From: Wagner, David B (PDS)
Sent: Wednesday, August 19, 2015 3:50 PM
To: 'Grace Bryan'
Subject: RE: Land Development Meeting on 7/23 15Zone1015

PUBLIC HEARING
**ZONING
CHANGE**
RR to R5A
CASE #15Z0NE1015
DATE: AUGUST 20, 2015
THURSDAY 1:00 PM
514 WEST LIBERTY STREET
OLD JAIL BUILDING
THIS PROPOSAL MAY BE REVIEWED
AT PLANNING & DEVELOPMENT
DEPARTMENT OFFICE CENTER
440 S. 10th STREET, 12th FLOOR
HOUSTON, TX 77001 **574-6230**

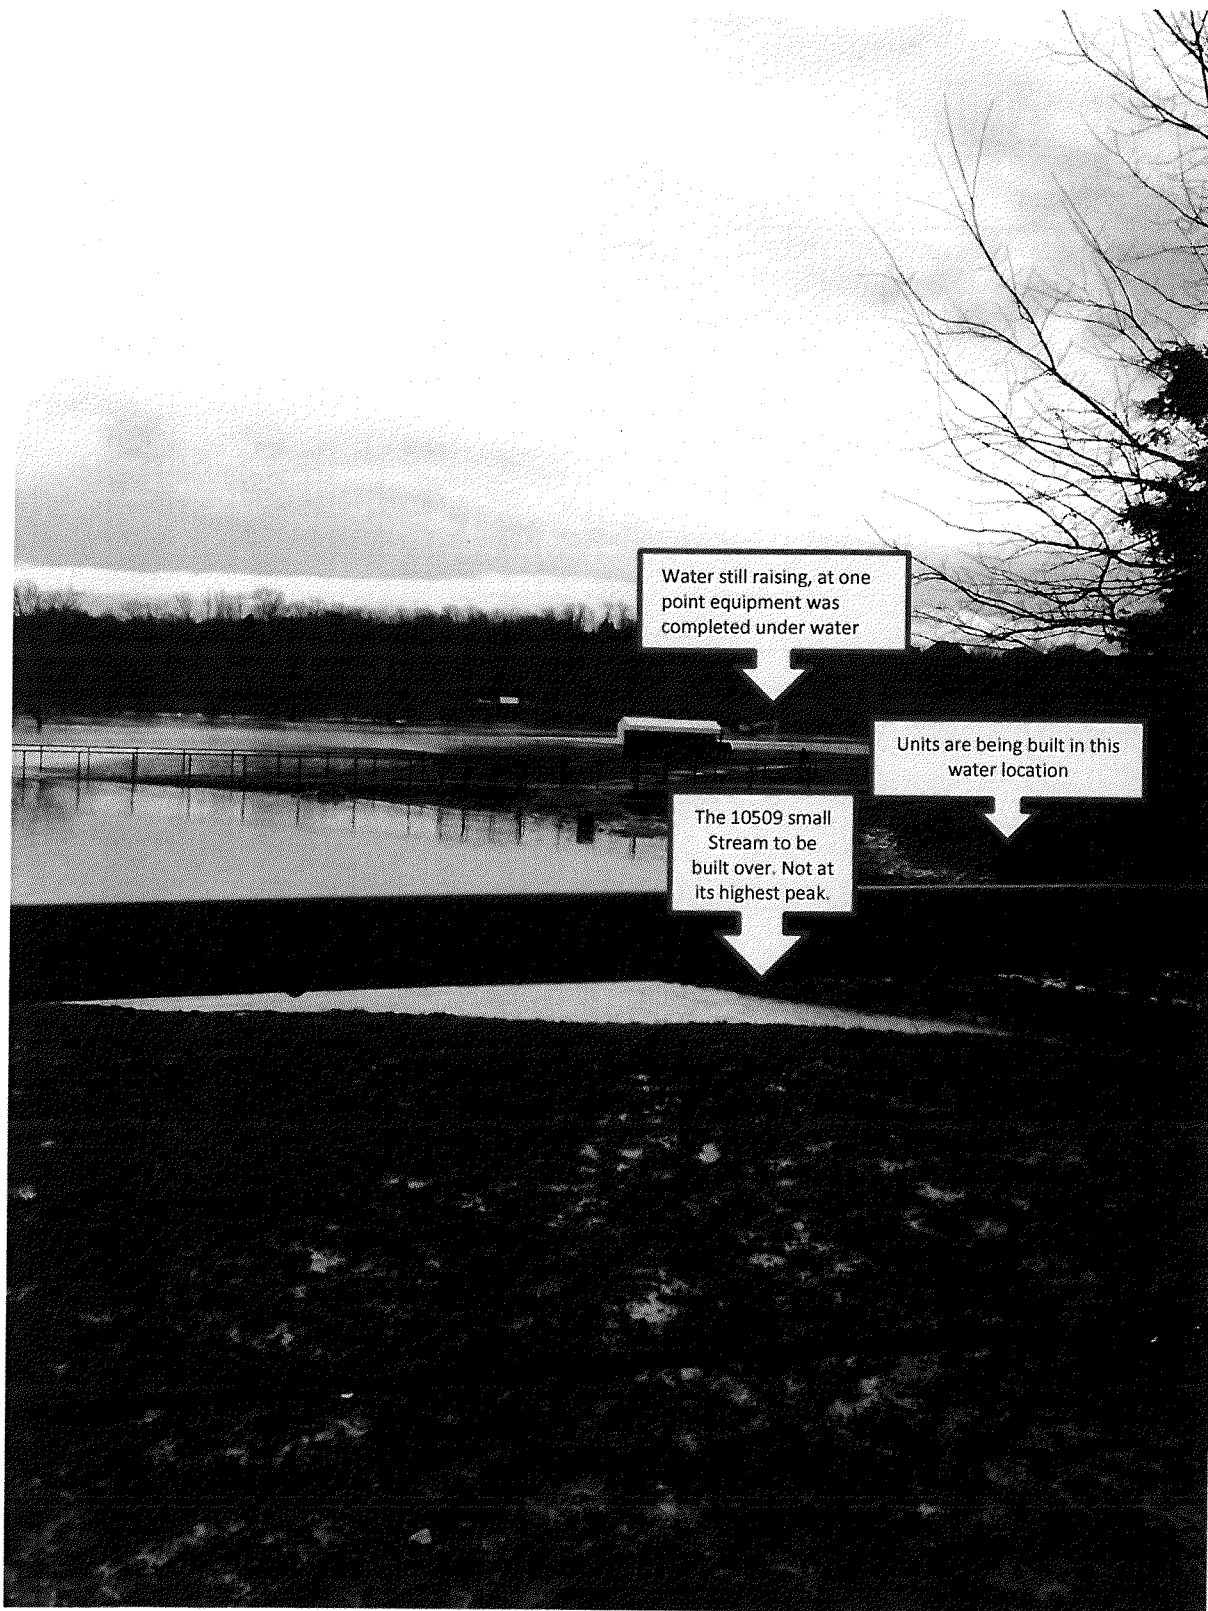
Below April 2015 picture is of the small stream on the 10509 property. The Parkland Bridge is in the background.
